SERVICE BULLETIN

N° **139-616**

DATE: June 19, 2024

ATA 53 - LOWER LH TAIL LONGERON INSPECTION AND REPAIR

Figure 16

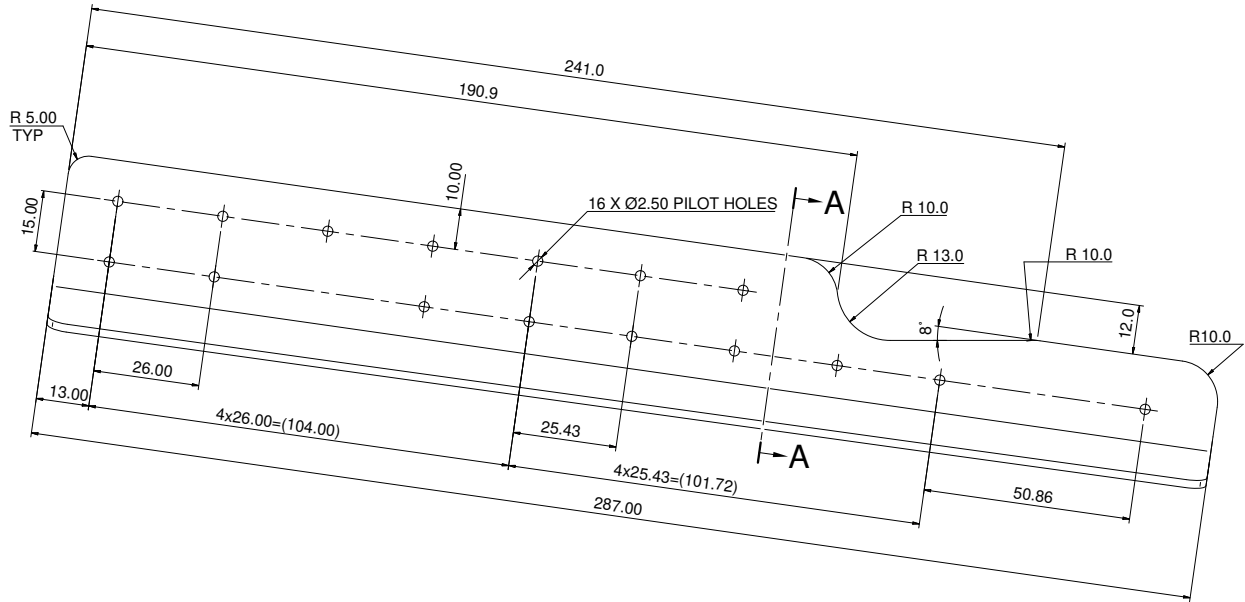
2. With reference to Figure 16, rework one plate AL-ALY 2024 (Thickness 2.00 mm) as indicated to obtain reinforcement angle and mark it as P/N 3G5350R01052.
